Determining SNR_{ISI} for Clause 136 and Clause 137 (comment #209 and #210)

Richard Mellitz, Samtec

IEEE P802.3 50 Gb/s, 100 Gb/s, and 200 Gb/s Ethernet Task Force, Huntington Beach, CA, January 2017

Test Conditions for drive swing

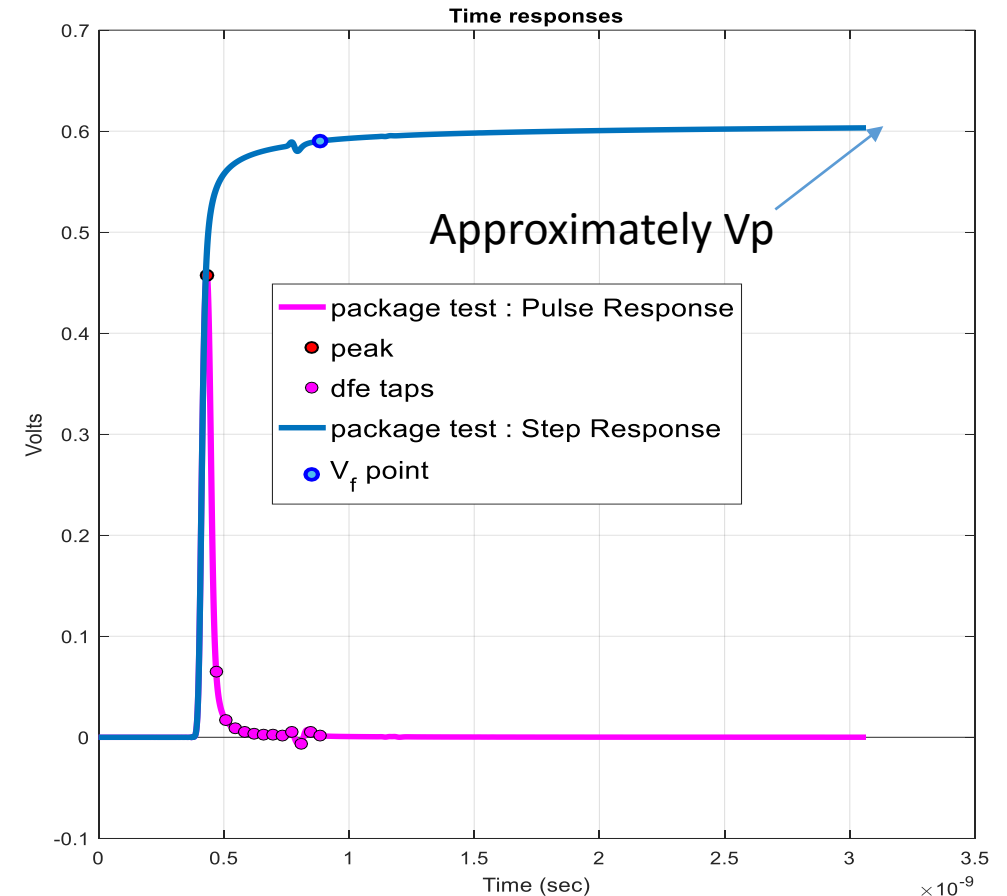
□ A_v and A_{fe}

- Limiting factor is Tx spec: $V_f \text{ min} = 0.4 \text{ v}$
 - which meets v_f / peak ratio (0.75)
 - V_f determined with $N_v=15$ for dfe12
 - 12 UI from peak
 - For considered values of R_d and Z_c

□ A_{ne}

- Limiting factor is Tx spec: $V_{p-p} 1200 \text{ mV}$
 - which meets v_f / peak ratio
 - $V_{p-p} < 1200 \text{ mV}$ for PRBS31 ($V_p=0.6 \text{ v}$)
 - 72 UI from peak
 - For considered values of R_d and Z_c

- ❑ For Clause 136 (Table 136–11) set SNR_{ISI} min to 30 dB
 - Allowing for about a dB of measurement error
- ❑ For Clause 137 set SNR_{ISI} min to 43 dB
 - 137.9.2 table: add 120D-1 modifications
 - Allowing for about 2 dB of measurement error
- ❑ Adjust drive amplitudes in COM according to tables in slides 5 and 6
 - Resolve COM parameters for Z_c and R_d in Ad Hoc
- ❑ Address Peak/ V_f in Ad Hoc
 - Values are a little high for clause 136
 - Values are a little low for clause 137
 - V_f values are also a bit high in COM package model

Host Transmitter Test Set-Up Clause 136

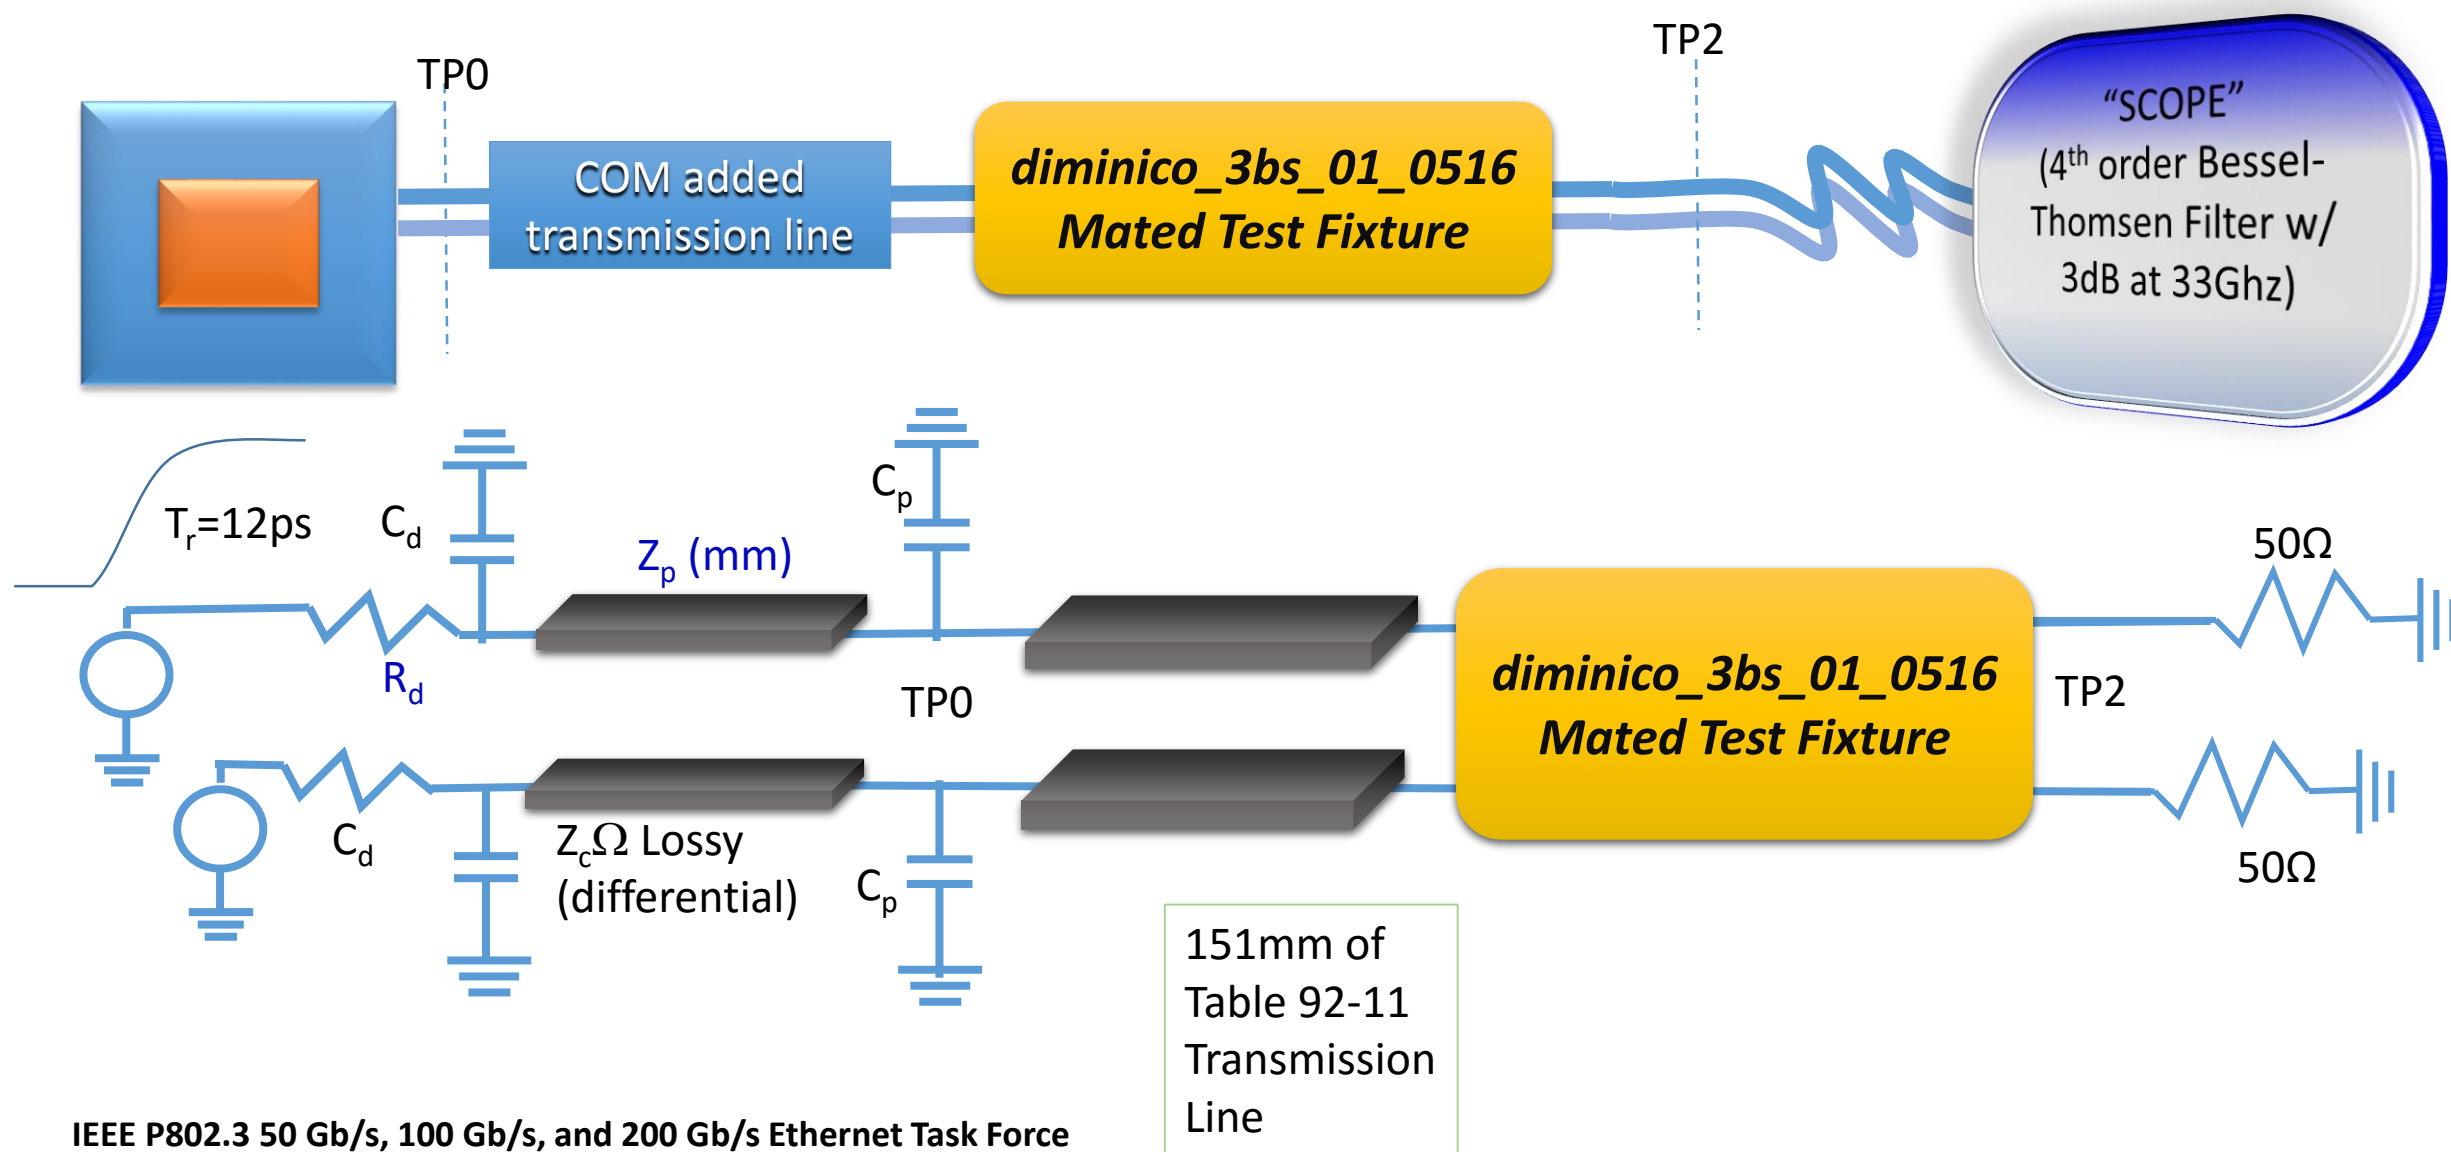
Host under test model from COM

Victim and Far End Simulation Data for COM reference package at TP2
 $Tr=12\text{ ps}$, $N_v=15$ using
package plus 151 mm COM board trace and diminico_3bs_01_0516
